<b>Docket Number:</b>	93-AFC-03C
<b>Project Title:</b>	Compliance - Application for Certification for SMUD's Campbell Soup Cogeneration Project
<b>TN #:</b>	232898
<b>Document Title:</b>	SPA Campbell Cogeneration Project Water Storage Tank Petition to Amend
<b>Description:</b>	SPA's Petition for Post-Certification License Amendment
<b>Filer:</b>	Jerry Salamy
<b>Organization:</b>	Jacobs
<b>Submitter Role:</b>	Applicant Consultant
<b>Submission Date:</b>	5/1/2020 1:46:12 PM
<b>Docketed Date:</b>	5/1/2020

<b>In the Matter of:</b>	)	<b>Docket No. 93-AFC-JC</b>
	)	
<b>Campbell Cogeneration Project</b>	)	<b>SPA's PETITION FOR POST-</b>
	)	<b>CERTIFICATION LICENSE</b>
_____	)	<b>AMENDMENT</b>

Fire Water Storage Tank for  
the Sacramento Power Authority's  
Campbell Cogeneration Project (93-AFC-3C)

Petition for Modification

**Figure 2. Water Storage Tank Equipment**  
SPA Campbell Cogeneration Project

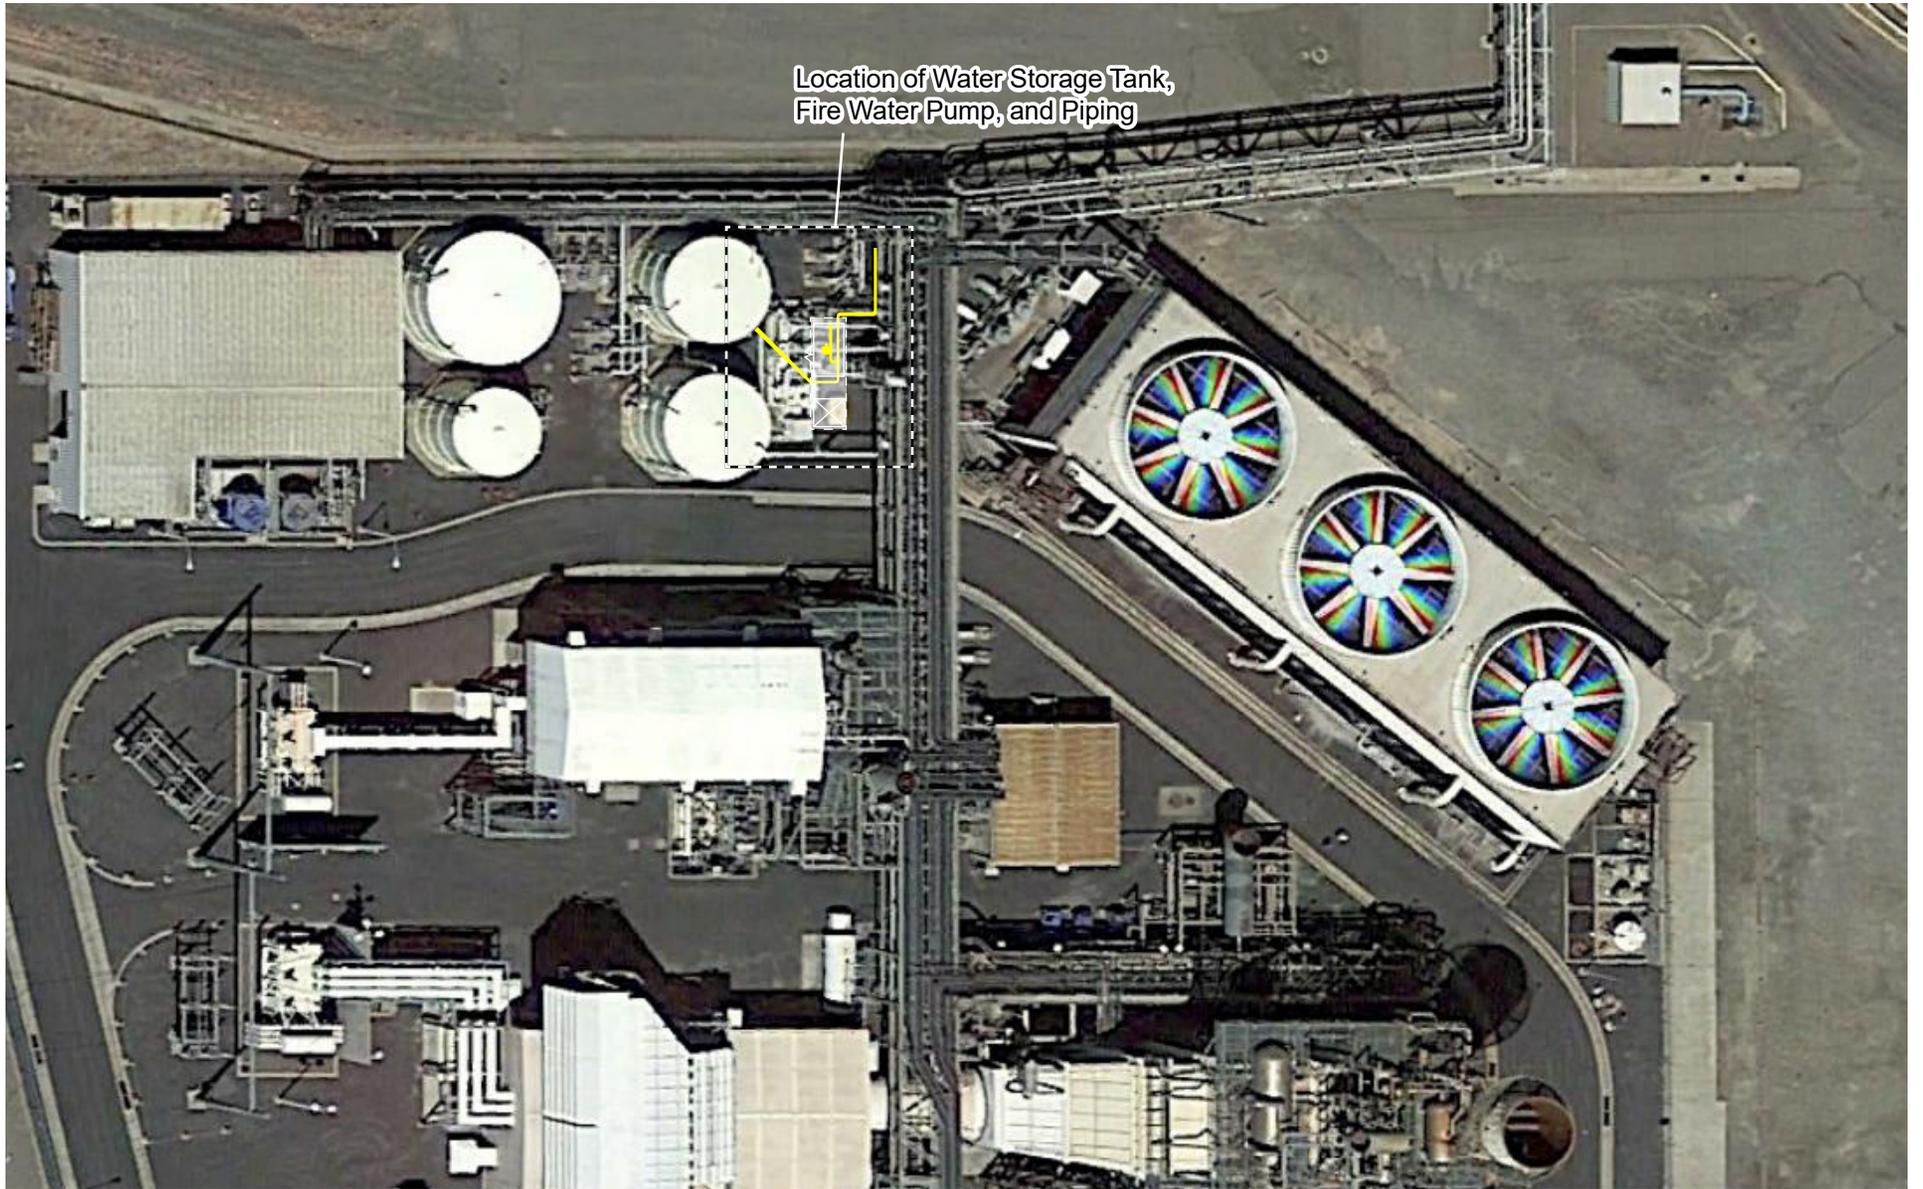
SPA proposes to repurpose an existing (100,000 gallon) condensate tank (used to receive condensate return from the former Campbell Soup facility) as a water/fire water storage tank (water storage tank) to store potable water, completely separating the City of Sacramento's drinking water distribution system from the cooling tower basin and all recycled water. The plan requires the replacement of the existing electric fire water pump located adjacent to the cooling tower with a new electric fire water pump to be installed on an existing foundation near the existing water/fire water storage tank. The new fire water pump and housing will be available for installation on June 4, 2020.

A new suction line (approximately 20 feet in length) from the water storage tank to the fire water pump will be installed, requiring several pipe supports to be installed. The pipe supports will require small footings (approximately 12 inches wide by 12 inches long by 12 inches deep) to be installed in the paved area between the water storage tank and the fire water pump. A new discharge line (approximately 20 feet in length) will also be required, requiring several footings of the same dimensions as the suction line. Figure 2 shows the location of the water storage tank, fire water pump, and the new water pipes. Figure 3 shows the fire water pump suction and discharge lines design.
